TYP. PEMB RIGID FRAME  
RAFTER/COLUMN MC CONNECTION  
RAFTER/RAFTER MC CONNECTION

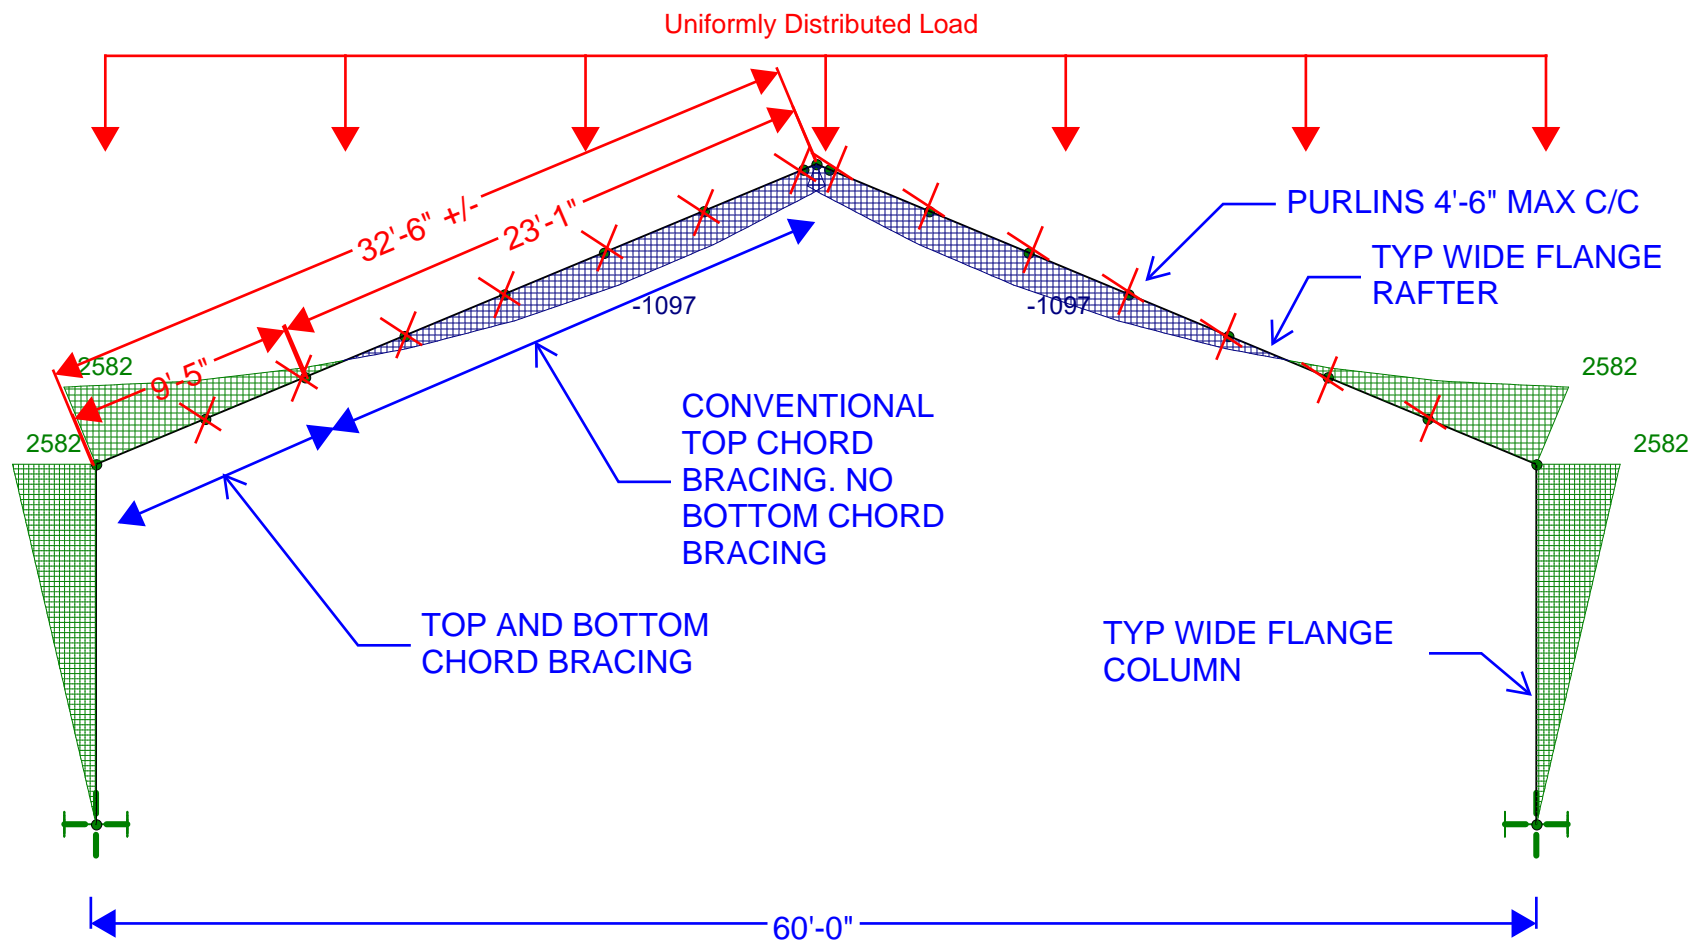
QUESTION: WHAT IS THE UNBRACED LENGTH OF THE  
COMPRESSION FLANGE OF RAFTER AT COLUMN WITH  
NEGATIVE MOMENT? 4'-6"? 23'-1"?
